**AMENDMENTS TO THE DRAWINGS:**

## REMARKS

Application No. 10/813,610  
Reply to Office Action Dated 09/20/05  
ANNOTATED SHEET

Fig. 7

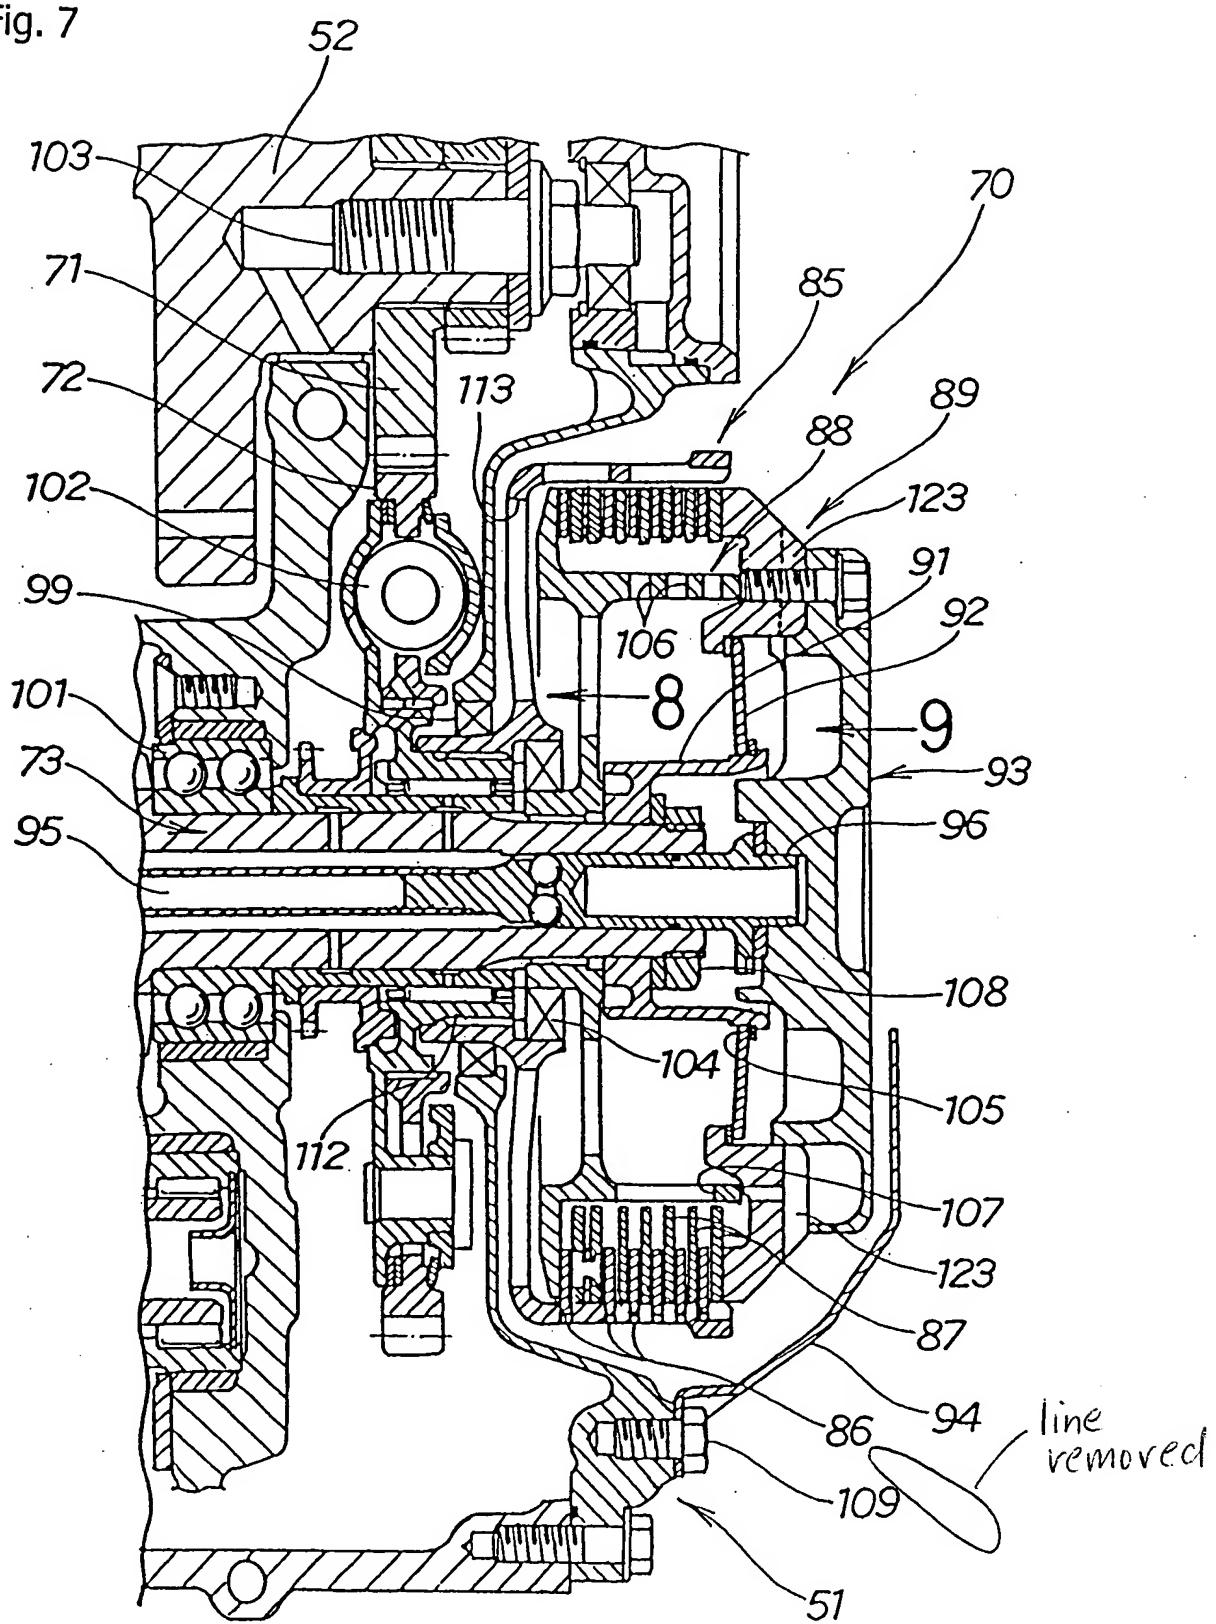
A drawing sheet which includes only Fig. 7, replaces the original sheet which included only Fig.

7. In Fig. 7, an extraneous line has been removed.

Fig. 9

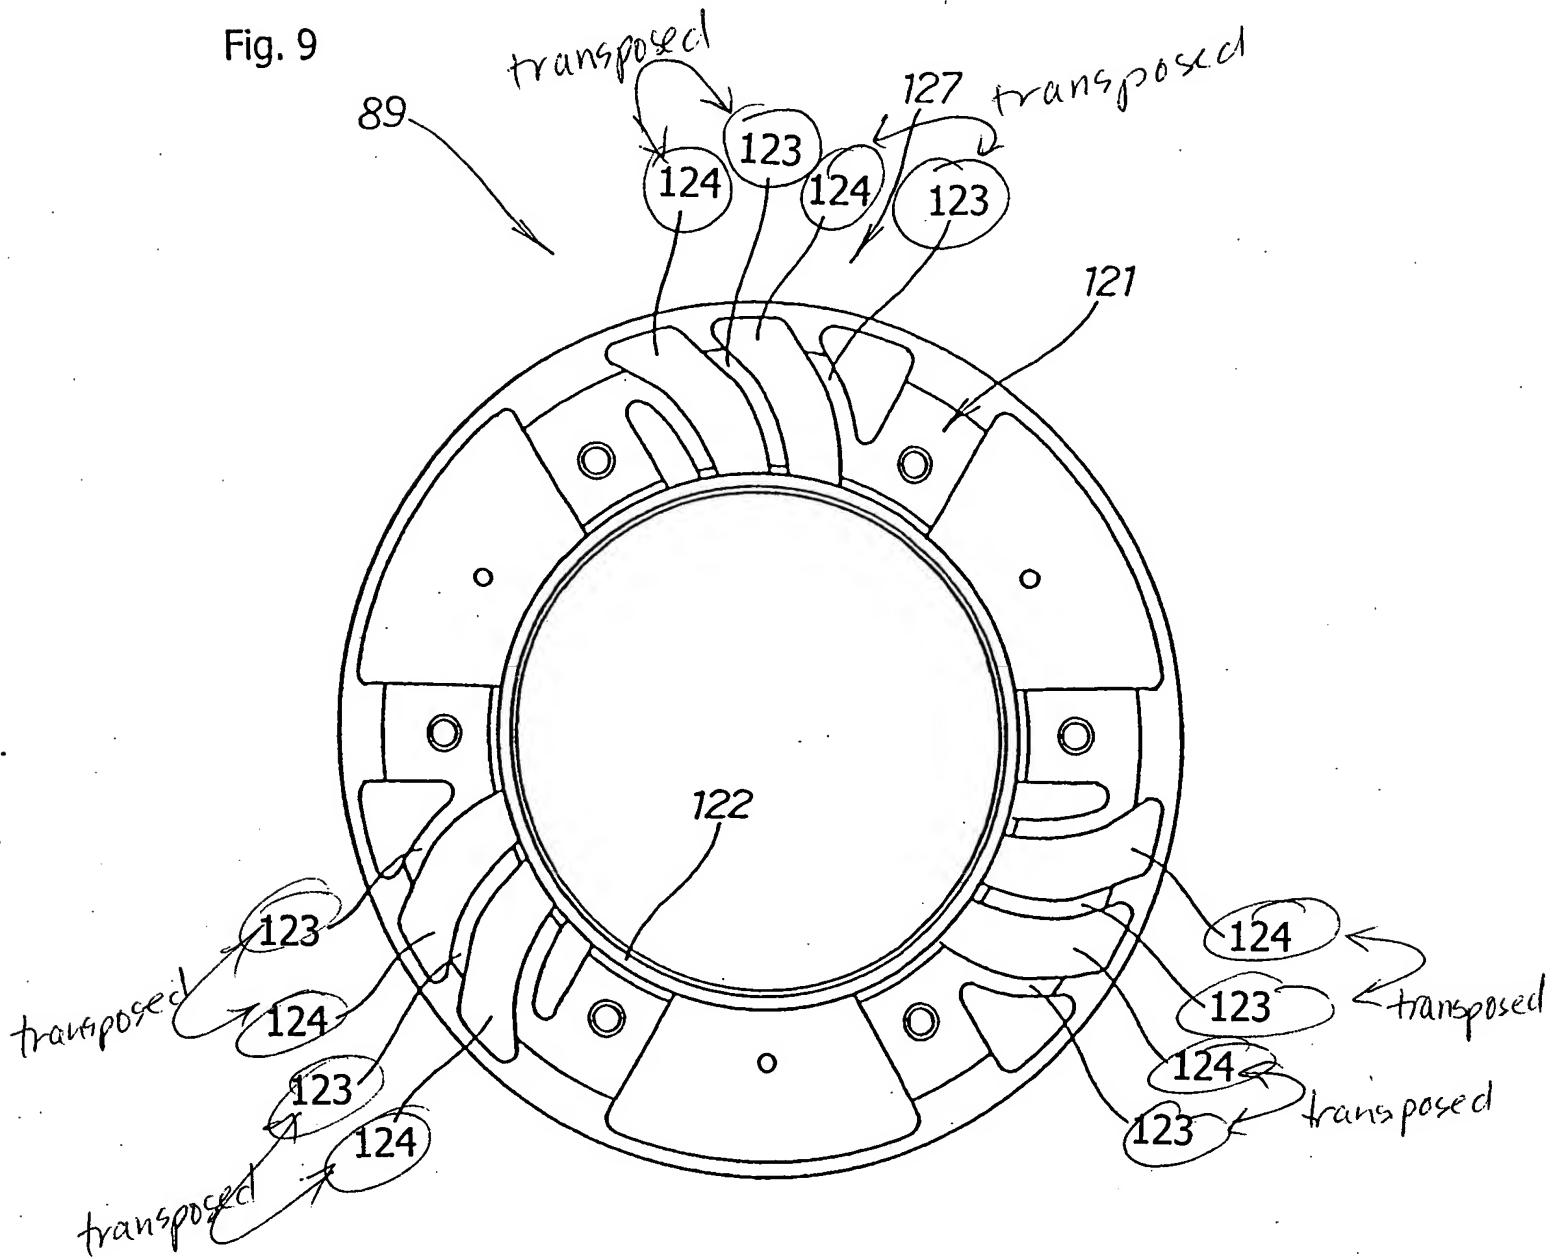
A drawing sheet which includes only Fig. 9, replaces the original sheet which included only Fig.

9. In Fig. 9, previously transposed reference numbers 123 and 124 have been corrected, so that reference number 123 indicates a passage and reference number 124 indicates a fin. This correction permits Fig. 9 to be consistent with the written description.

Fig. 11

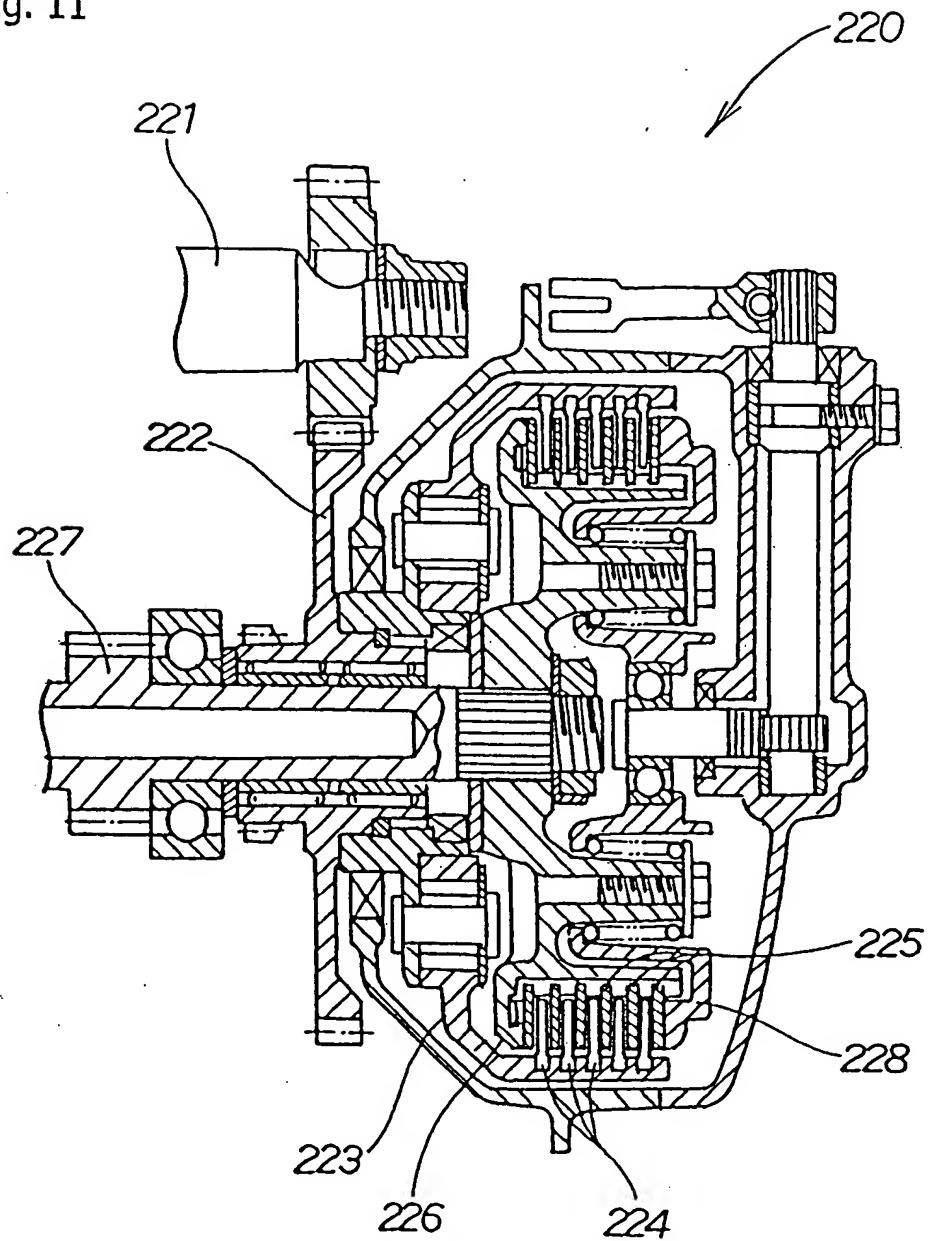
A drawing sheet which includes only Fig. 11 replaces the original sheet which included only Fig.

11. In Fig. 11, the figure label "PRIOR ART" has been added.

Previously omitted label is added.
